DATE: 3/14/2022	JOB NO: 2021085
ATTENTION: Ms. Janet Guerra	
RE: 617 North Broadway Revised Modifications to Existing Site

Reference: Revisions to proposed site plan  
617 North Broadway  
Upper Nyack, NY 10960  
SEA Project No. 2021085

PROJECT:	MODIFICATIONS TO SITE 617 NORTH BROADWAY UPPER NYACK, NY	
DRAWING:	PROPOSED SITE PLAN	
DATE	PROJECT NO.	DRAWING NO.
12/7/2021	2021085	SEA-100

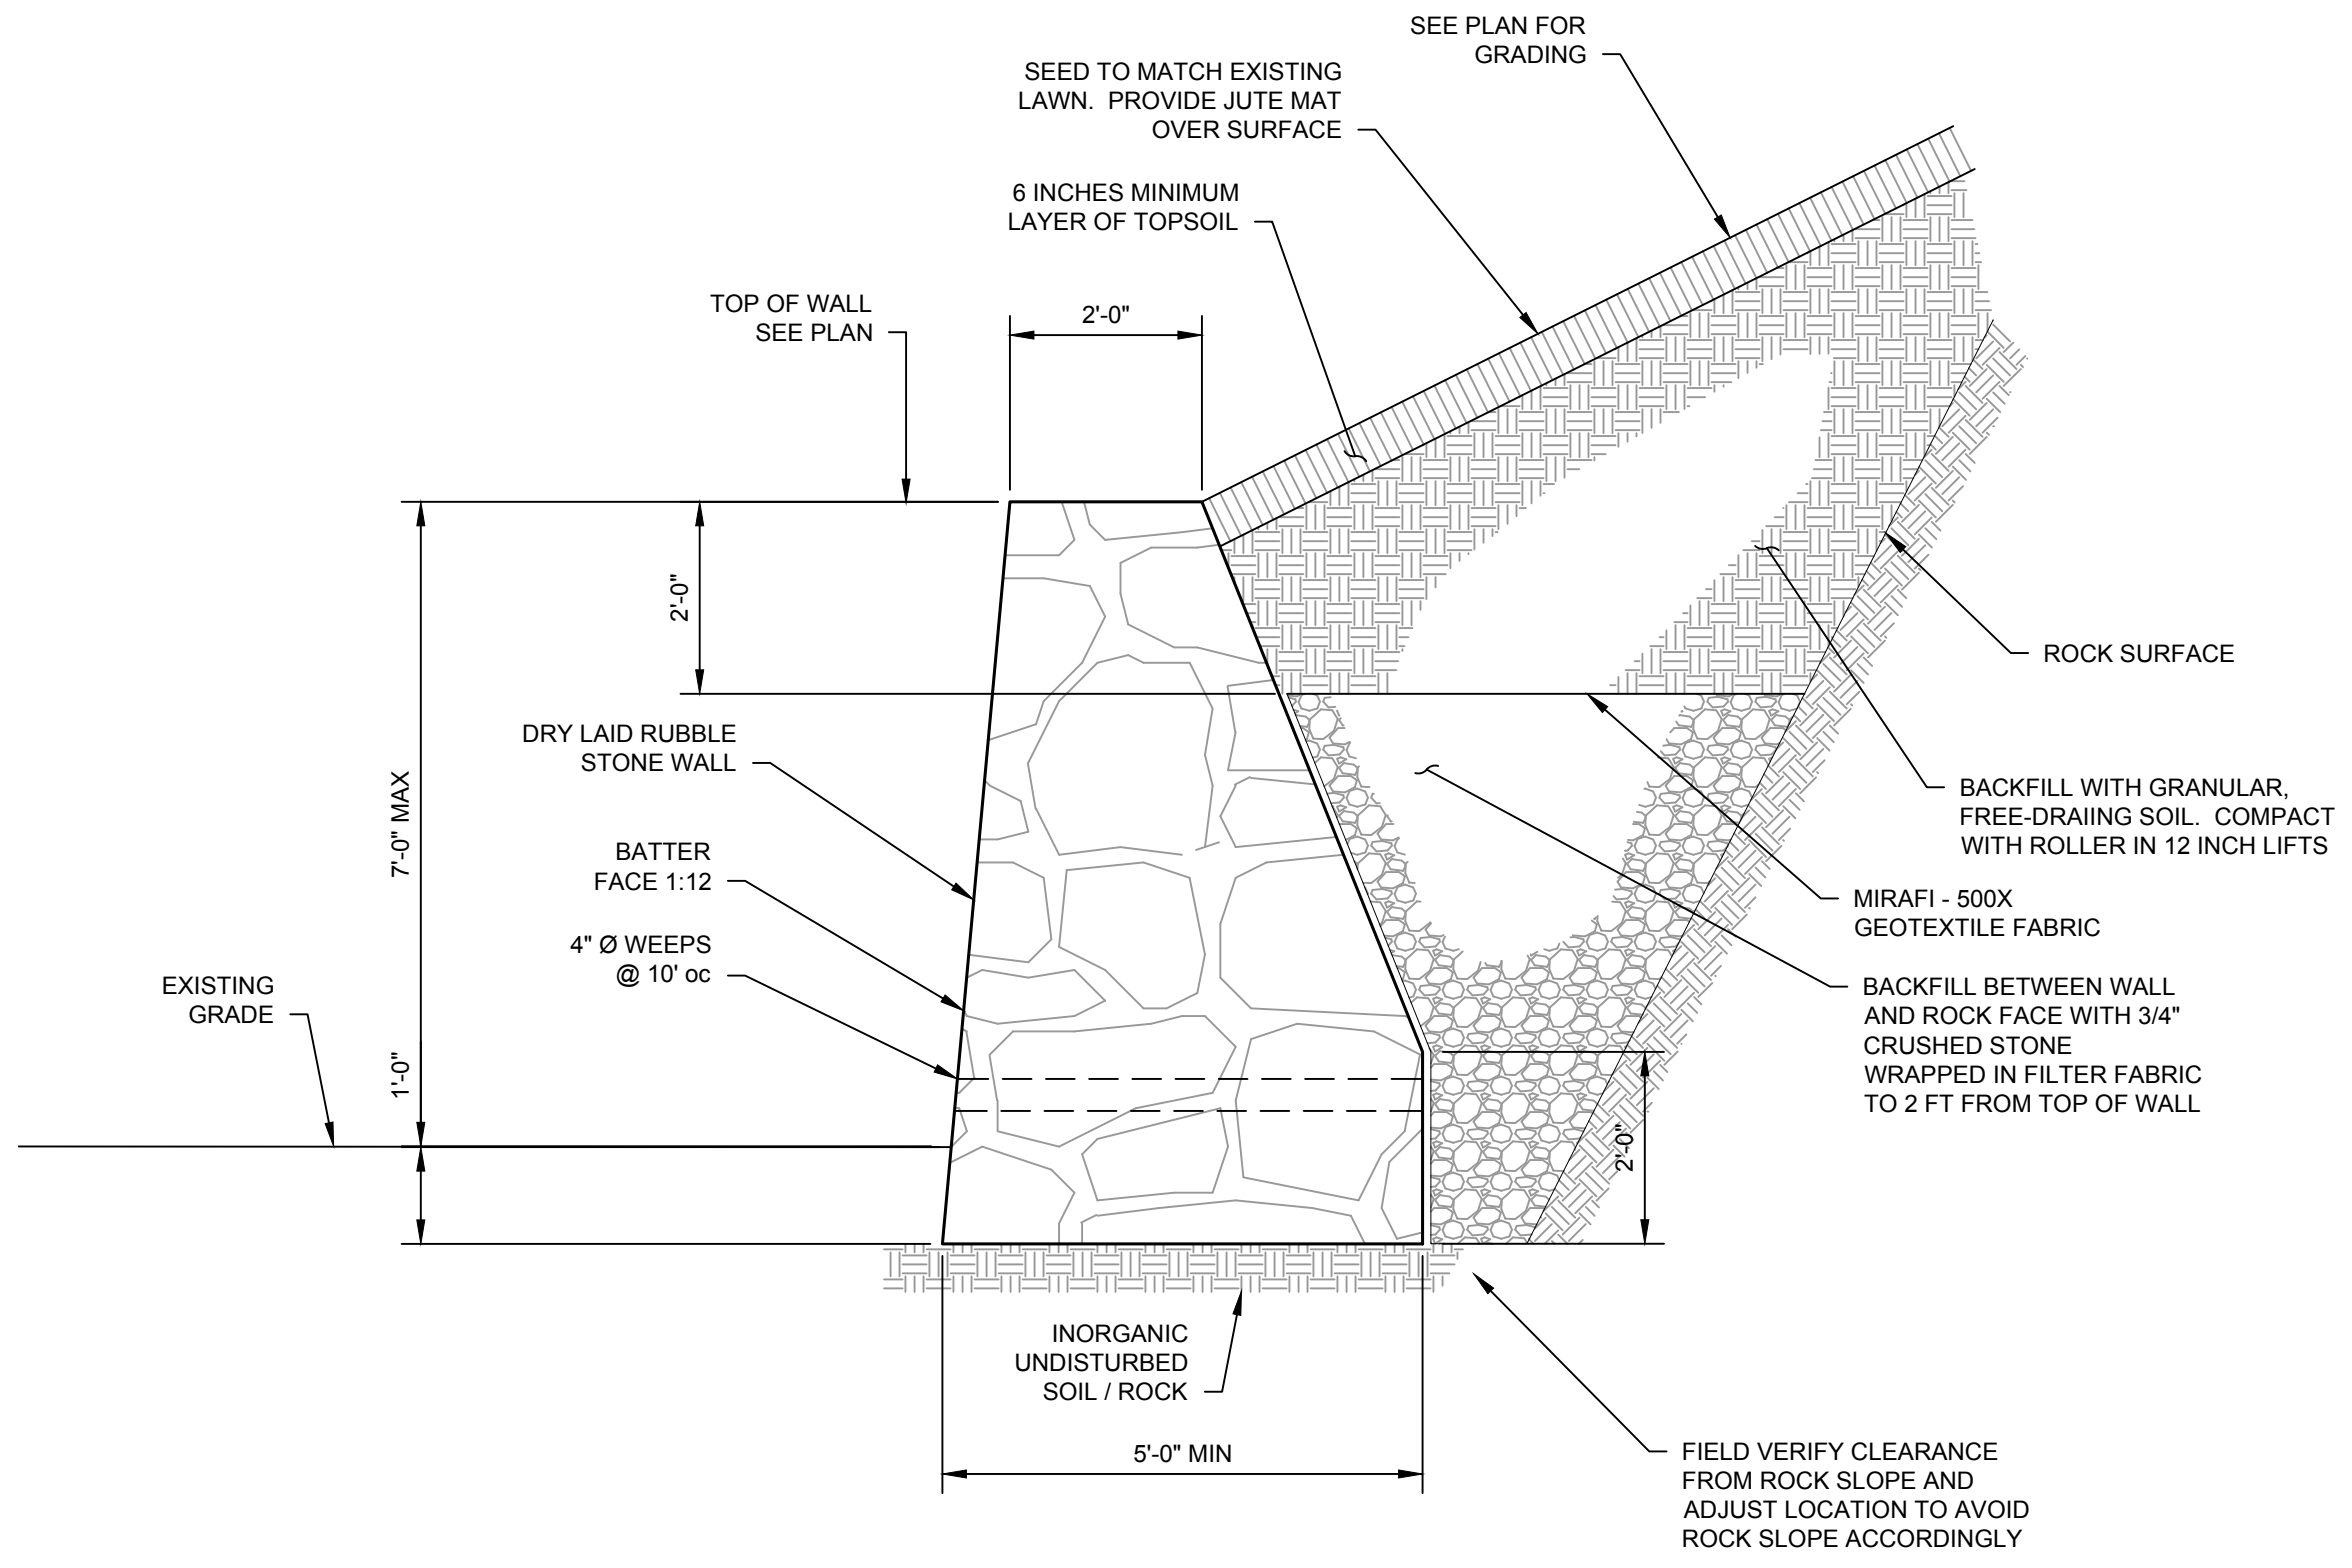
- Comment No. 3. The wall has been shifted approximately five feet to the east to allow for adequate clearance of the base of the wall from the rock slope. Additionally, a note has been added to the Typical Retaining Wall Section stating that the clearance will be field verified during construction and the wall location adjusted accordingly.

- Comment No. 4. The Typical Retaining Wall Section has been revised to show type of crushed stone backfill, geotextile specification, soil backfill and placement requirements, topsoil and seed requirements.

- Comment No. 6. The Typical Retaining Wall Section has been revised to show the 1:12 batter face.
- Comment No. 7. The silt fence detail has been replaced with the silt fence detail from the NYS Standards and Specifications for Erosion and Sedimentation Control – Figure 5.30 “Reinforced Silt Fence.”

- Comment No. 8. The original limit of disturbance line has been added to the proposed site plan.
